**Operator: BONANZA CREEK ENERGY OPERATING COMPANY LLC**

**Location Name: Antelope F-15 Pad**

**Loc ID: 429977**

**Inspection: 696305514**

Exhibit A

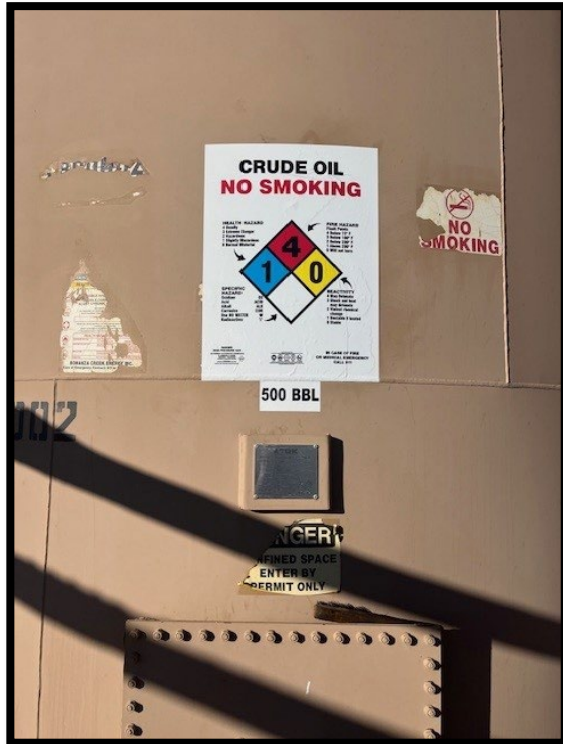
**CA:** EAST TANK BATTERY LABELS - #1336 - NFPA and Content. #220404 - Content, Capacity and NFPA. #220403 - NFPA. #220402 - Capacity and Content. #220401 - NFPA. East side of East Tanks - far North Tank - Capacity. Far South Tank - Content, Capacity and NFPA. See photos. Install sign to comply with Rule 605.h.

**CA Resolution:** Operator has installed updated NFPA and Capacity signage on the identified tanks. Contents signage is in the process of being installed to ensure the site complies with Rule 605.h.
